PLANNING REVIEW CHECKLIST

Subject Property: 1341 Waller Street SE

Reference No.: 23-101404-PLN

Site Plan Review Class 3
Fahlman Glaze Apartments
1341 Waller St., Salem, Or

APING PLAN

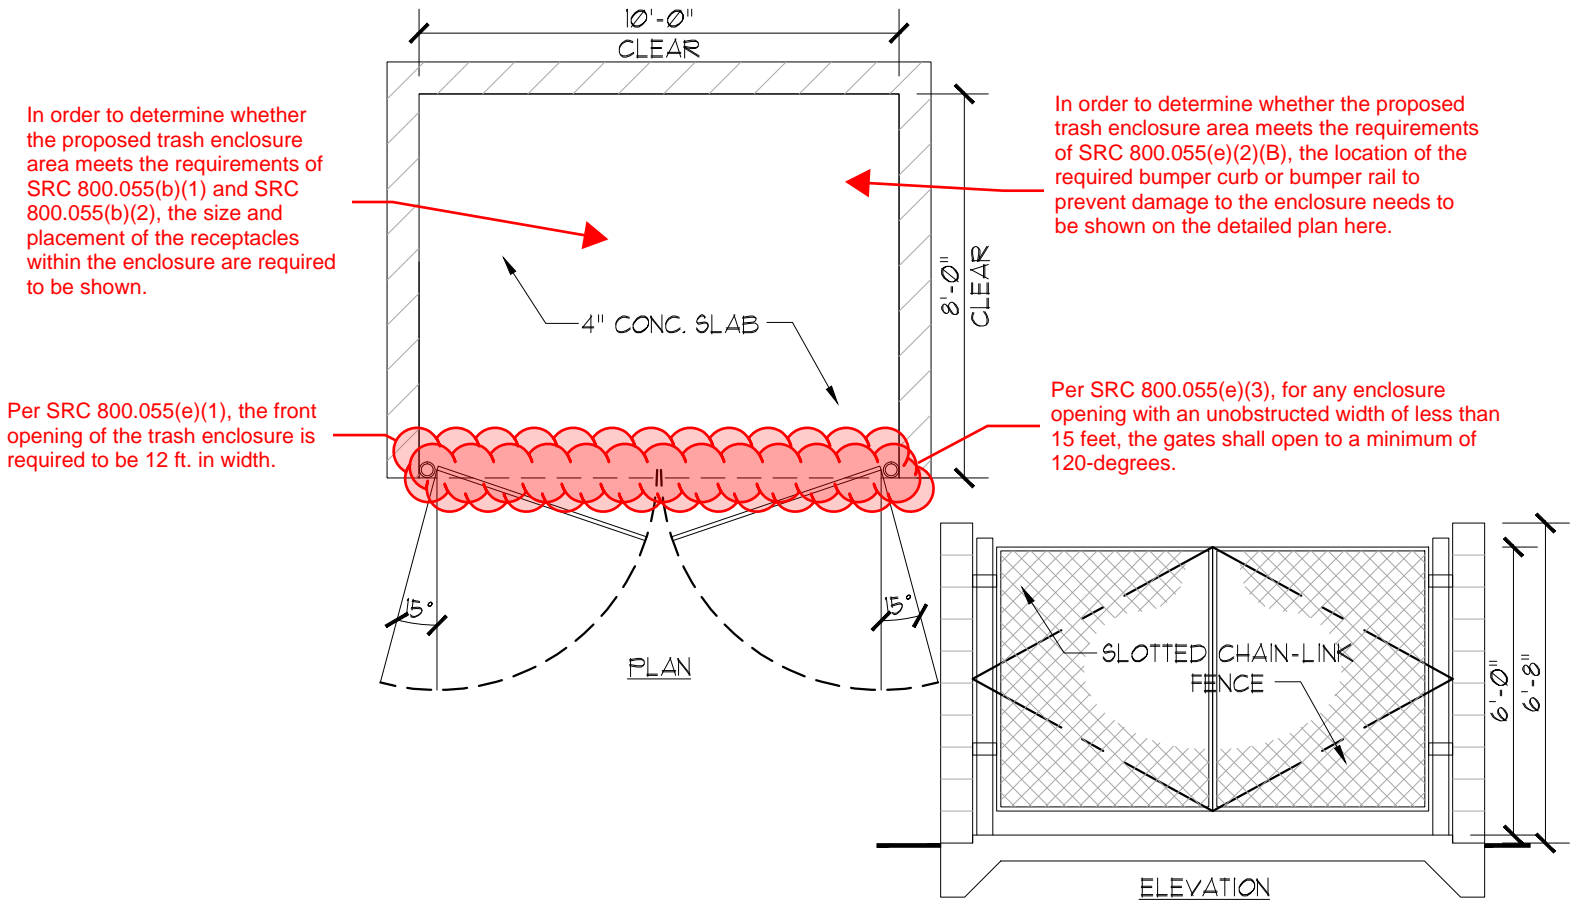
Per CO Zone setback table (Table 521-3), interior side and rear setbacks are required to meet the Type C landscaping requirement of SRC Chapter 807 which requires a min. of 1 plant unit per 20 square feet of landscaped area together with a minimum 6-foot-tall sight-obscuring fence or wall.

The landscape plan does not identify any landscaping or screening to visually and physically separate the ground-level private open space patio areas from the common open space. The landscape plan needs to be revised to identify how the proposed ground floor patio areas will be visually/physically separated from the common open space areas as required under SRC 702.020(b)(6).

Building 1 Plant Units Required:
-Trees: 36 pu req. / ??? provided

Building 2 Plant Units Required:
-Trees: 36 pu req. / ??? provided

Building 3 Plant Units Required:
-Trees: 13 pu req. / ??? provided

No upper floor balcony shown here, but balconies are shown on the building elevations.

It appears that more than 30 percent of the critical root zone of this tree is/will be disturbed, which exceeds the maximum amount allowed under SRC 808.046(a)(3)(A).

Per SRC 700.020(b)(7), a minimum of one canopy tree is required to be planted along every 50 ft. of the perimeter of parking areas. The trunks of the trees are required to be located within 10 ft. of the edge of the parking area.

Based on the length of the proposed parking area being more than 50 ft., one canopy tree is required to be planted along the perimeter of the proposed parking lot.

The species of trees proposed to be planted around the perimeter of the buildings is needed in order to determine whether the proposed development will meet the tree planting requirement around buildings per SRC 702.020(b)(4).

This proposed ground floor private open space area does not meet the min. required 96 square feet or the min. required 6-foot dimension in all locations.

The species of trees proposed to be planted around the perimeter of the buildings is needed in order to determine whether the proposed development will meet the tree planting requirement around buildings per SRC 702.020(b)(4).

The species of trees proposed to be planted around the perimeter of the buildings is needed in order to determine whether the proposed development will meet the tree planting requirement around buildings per SRC 702.020(b)(4).

TRASH ENCLOSURE

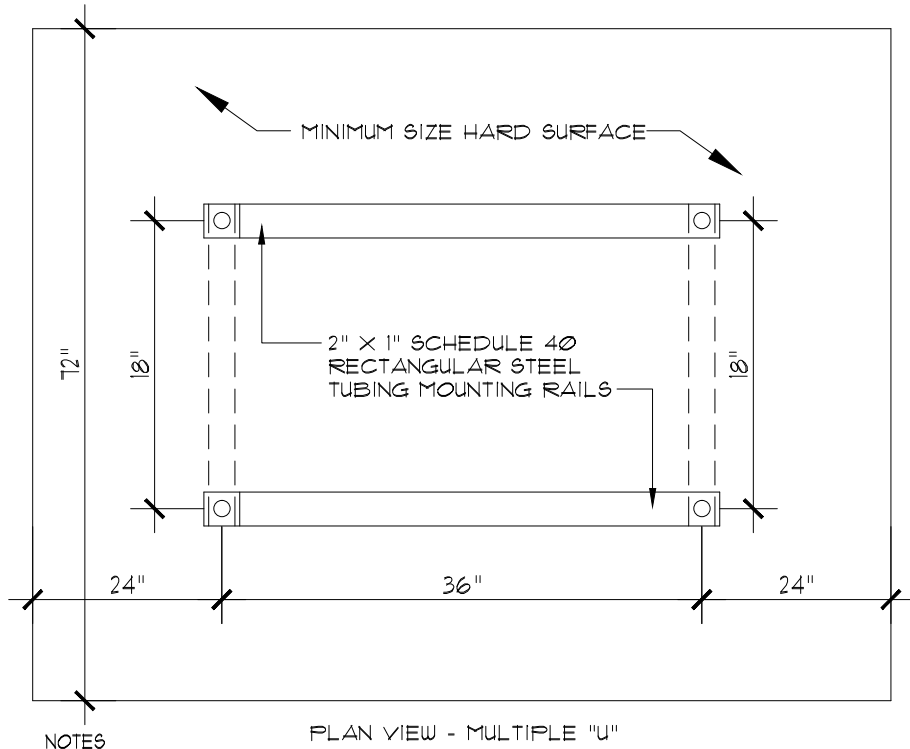
Per SRC 800.055(f)(1)(A) & (B), because the vehicle operation area serving the trash enclosure will not be located perpendicular to the front opening of the enclosure, the trash receptacles used are required to be two cubic yards or less in size.
